SUMMARY INFORMATION

CAPACITY MARKET CODE MODIFICATIONS CONSULTATION COMMENTS:

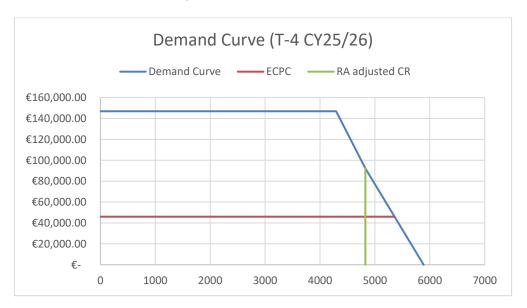
Below is the demand curve for the T-4 CY25/26 auction. From the information currently available, the TSO capacity requirement was adjusted backwards by the RAs to 4,826MW. When the auction cleared near the ECPC it procured ~530MW (11%) more than needed for the RA adjusted capacity requirement.
